LINCOLN CITY/LANCASTER COUNTY PLANNING STAFF REPORT

for April 27, 2004 PLANNING COMMISSION MEETING

PROJECT #: Special Permit #04067, Use Permit #139A

PROPOSAL: To remove a portion of the existing use permit and incorporate that portion into a special permit for a community unit plan, and increase the use permit area to meet the minimum area requirement for the I-3 district.

Stone Bridge Creek - The Villas
SITE PLAN EXHIBIT
CITY, LINCOLN, NEBRASKA

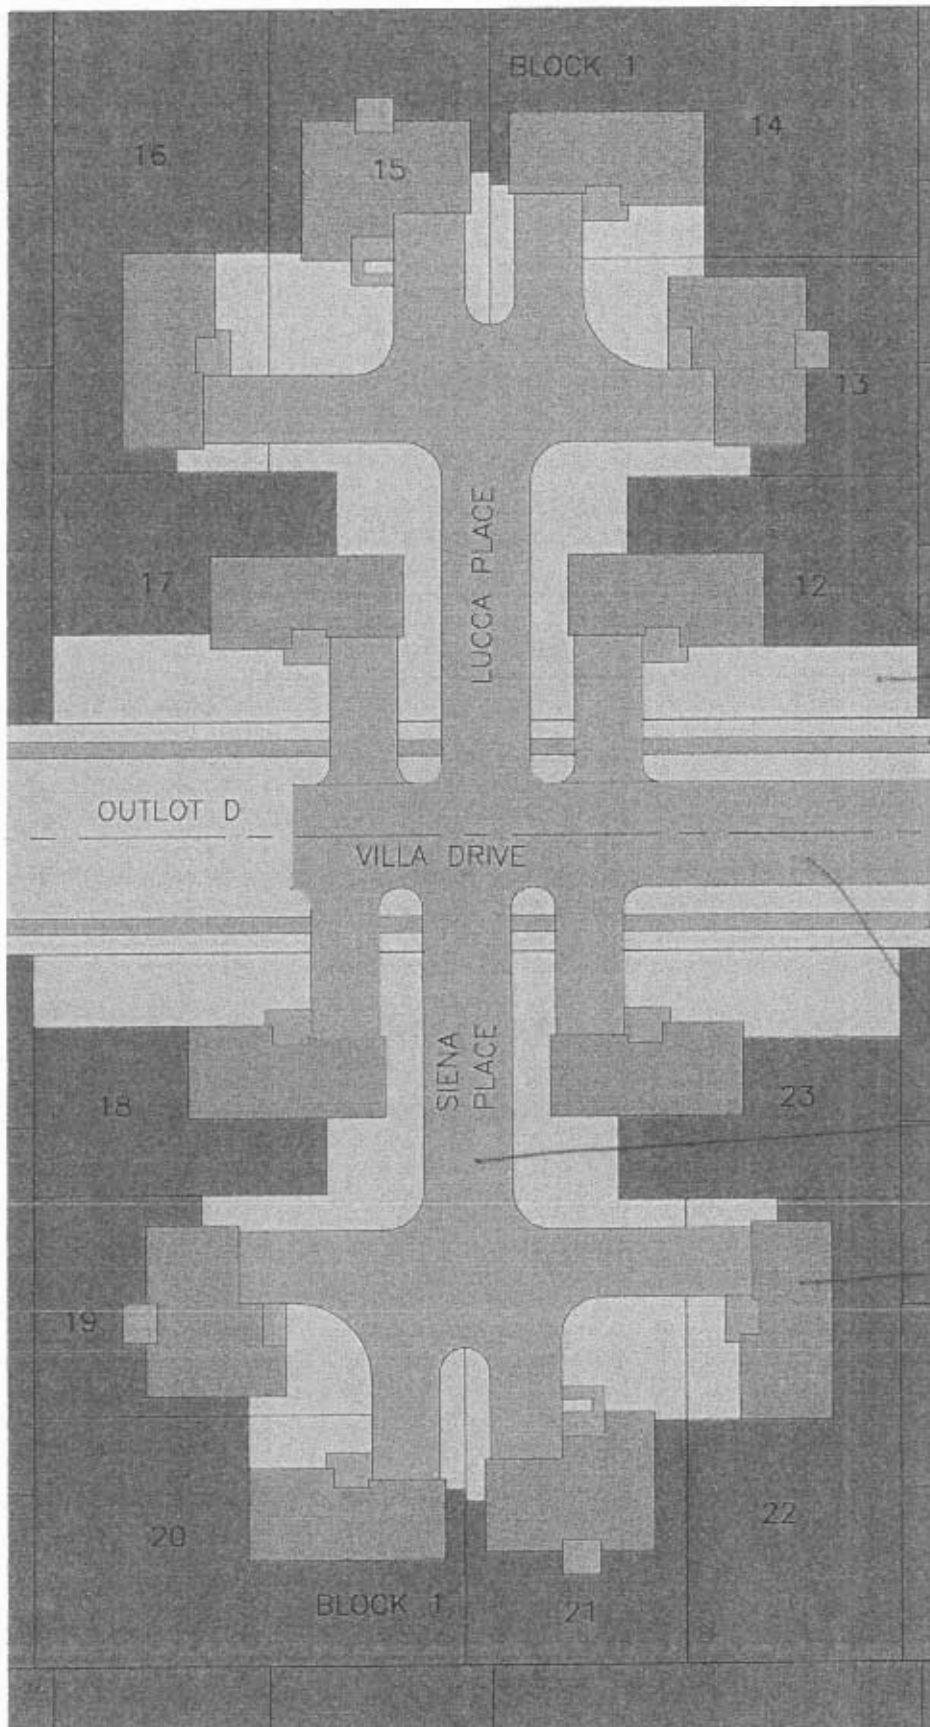
3. The applicant indicated this is an innovative design of the cul-de-sacs, which led to a smaller parkway which made it difficult to provide a sidewalk as well as enough space to gain access to the utilities for maintenance purposes without having to replace the sidewalk. The applicant also indicated that the cul-de-sacs serve a small number of units and pavement is proposed without curb and gutter allowing wheelchair access from either side. See attached exhibit.

4. Planning staff believes that sidewalks should be provided on both sides of all private roadways, and is an important safety feature for pedestrians. Sidewalks provide a safe place for people of all ages to walk, and or bike. Planning staff believes the problems cited by the applicant are self created and that minor redesign will provide the necessary area for the sidewalk. Planning staff believes the requests to modify front, side and rear yard setbacks, minimum lot width, depth and area are acceptable as this is a unique neighborhood concept. The coordination of the preliminary plat with the special permit process is an effective mechanism to streamline the development process and Planning staff recommends approval.

Stone Bridge Creek - The Villas
Cul-de-Sac Concept Exhibit

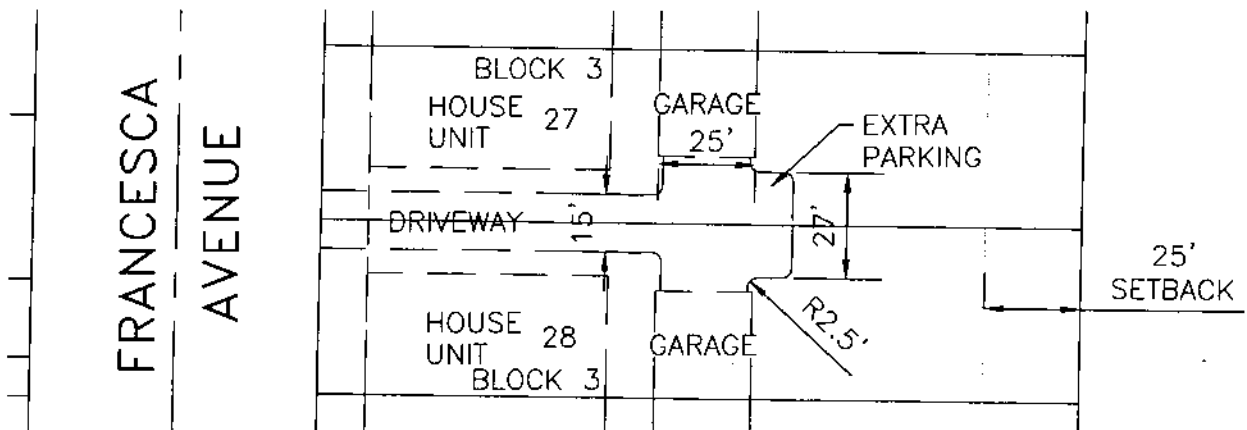
12. The cul-de-sac lots are setup specifically to create a new look for the development and a sense of community and identity with the design. The cul-de-sac lots will have building pads set for each lot ensuring the look and placement of each unit within the cul-de-sacs. Driveways for each unit will be long enough to provide parking in each driveway. The flag lots located within the cul-de-sacs are essential to achieving a functional design and the overall look of this element of the development. The cul-de-sac's provide different sized lots allowing for several different housing sizes that can be marketed to the young single professional, empty nesters looking to down size, or the family of 4 looking for a good neighborhood to raise their children (See colored cul-de-sac exhibit).

Stone Bridge Creek - The Villas
Common Lot Driveway Exhibit
Lincoln, Nebraska

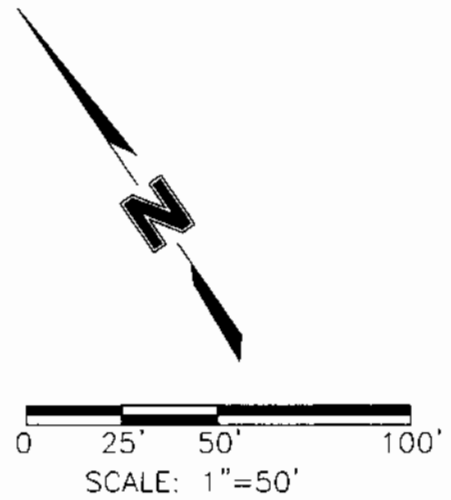
2.1.1.3 Include a detail on the site plan showing the common drive access for lots sharing access in Block 3.

rear of the dwelling unit is provided to ensure that the streetscape of Francesca and Palladian Avenue will be maintained. Additional parking spaces will be located at the back of each common drive giving each dwelling unit additional space for other vehicles (See common lot driveway exhibit).

Stone Bridge Creek - The Villas
Side Yard Setback Exhibit
 Lincoln, Nebraska

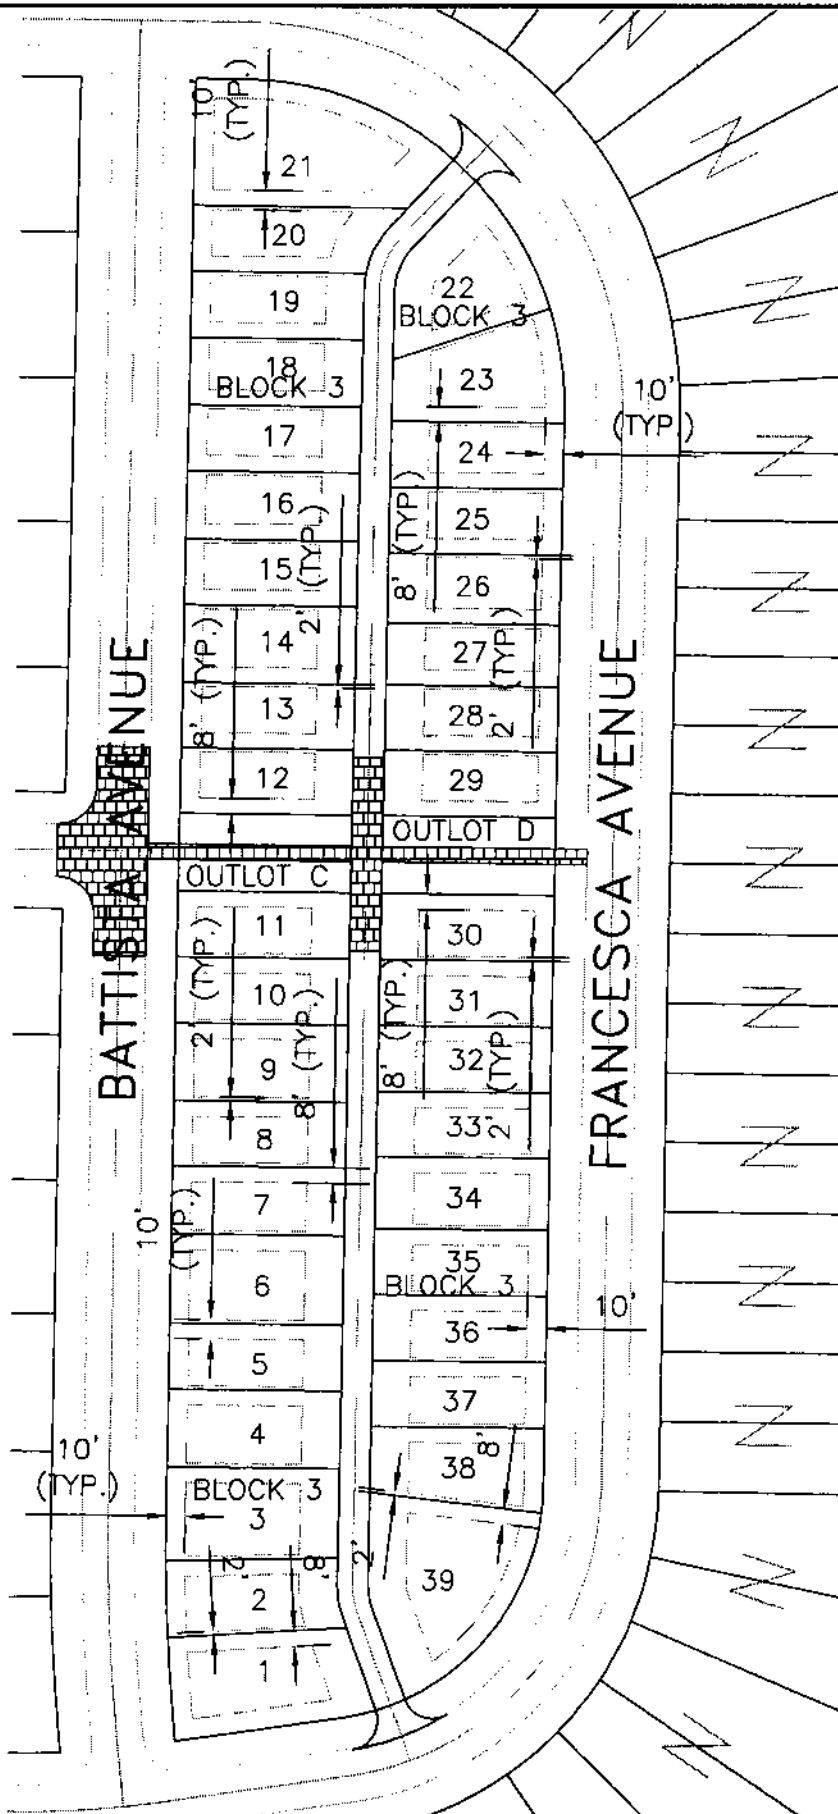
8. The side yard setbacks for Lots 1 – 39, Block 2 will be set at 2 feet on the non-active side of the lot and 8 feet on the active side of the lot to help create useable side yard space for each unit maintaining 10 feet between each unit. Building pads will be set on the lots to ensure that the side yard setback is maintained properly between each unit (See side yard setback exhibit).

Stone Bridge Creek - The Villas
SITE PLAN EXHIBIT
CITY, LINCOLN, NEBRASKA

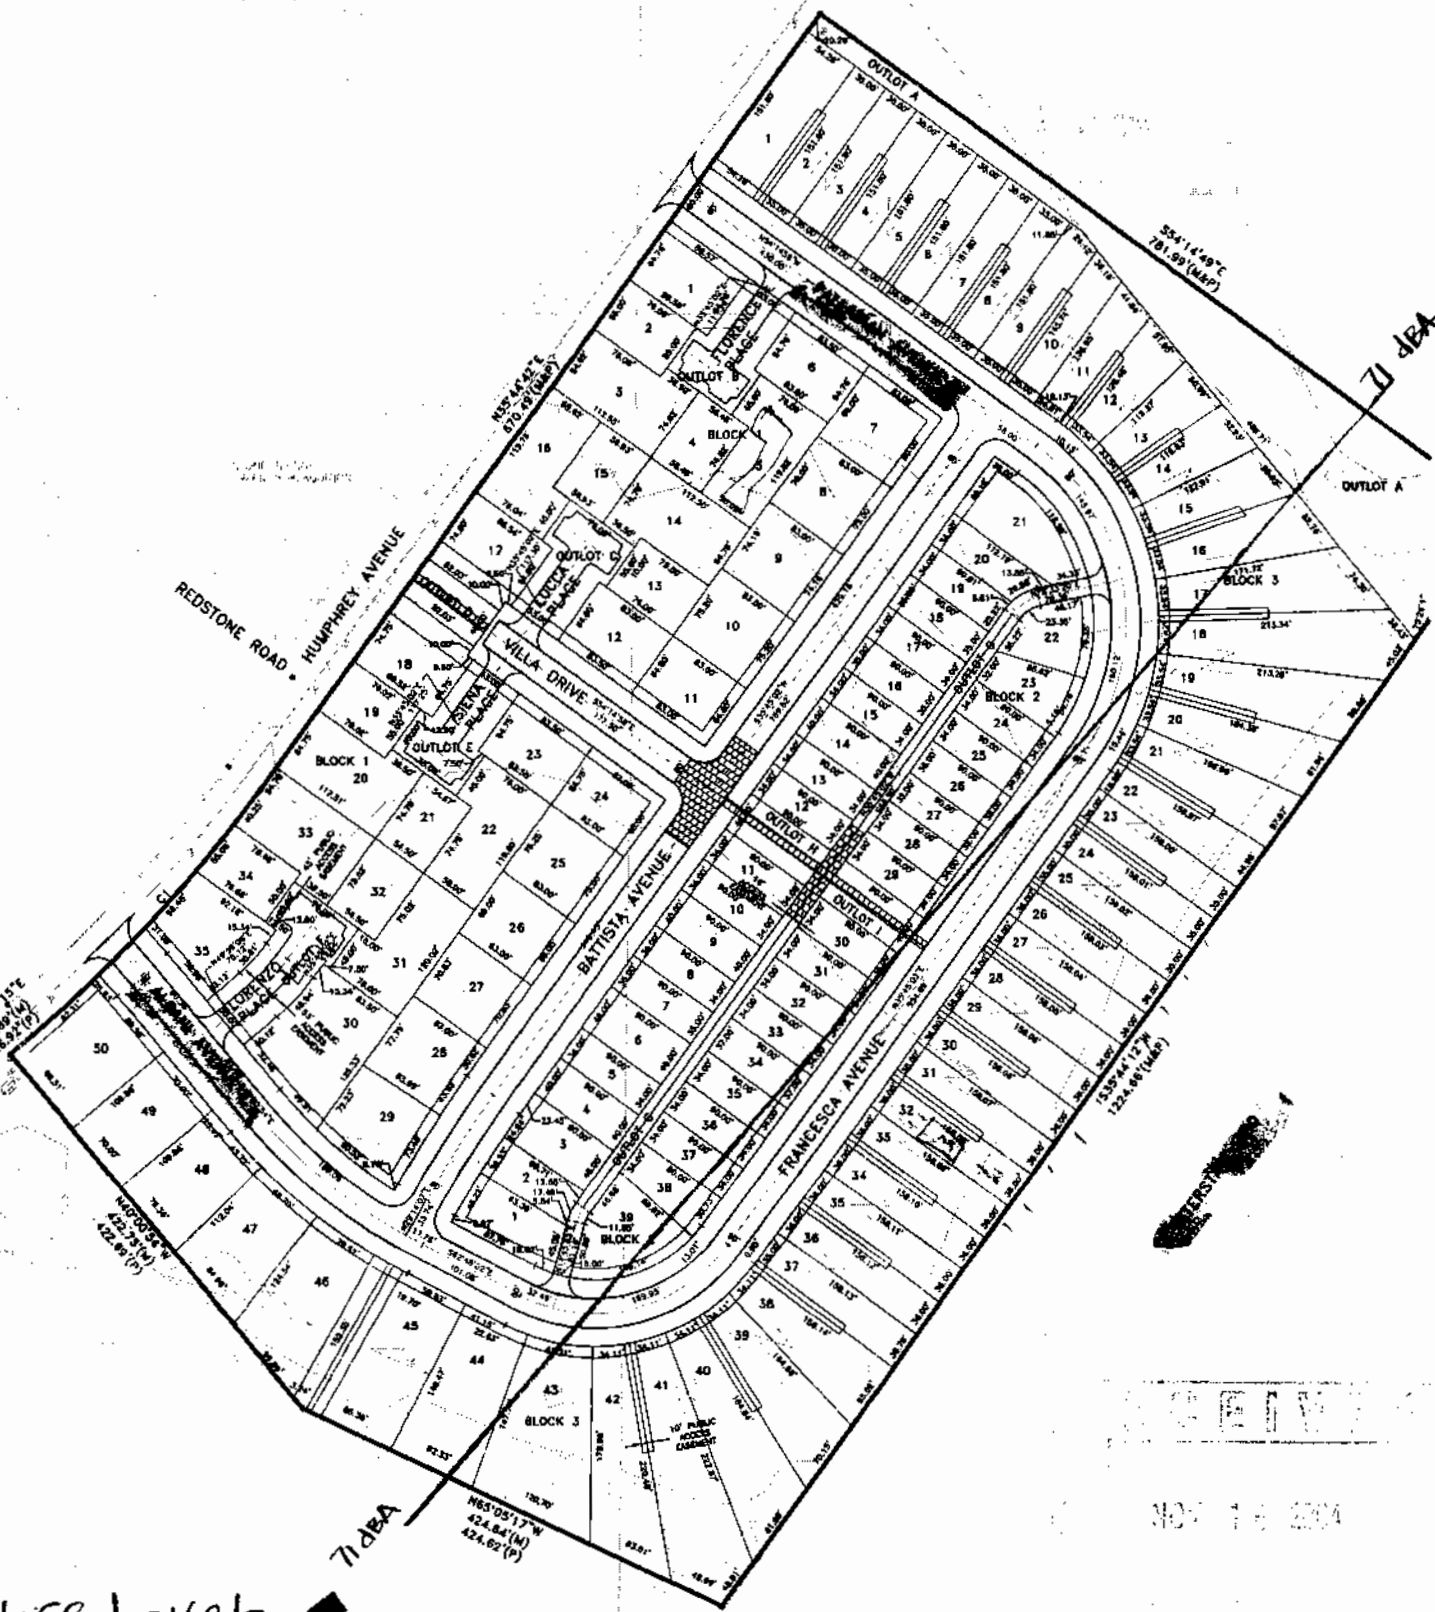
Review of the site plan for Stone Bridge Creek – The Villas shows that lots adjacent to I-80 would be over 71 dBA in the future design year situation (2020). A residential receptor is considered noise impacted at 66 dBA. Taking this into consideration, the entire Stone Bridge Creek – The Villas development is predicted to be noise impacted.

2.1.1.1 Noise mitigation measures to the satisfaction of the Lincoln Lancaster County Health Department.
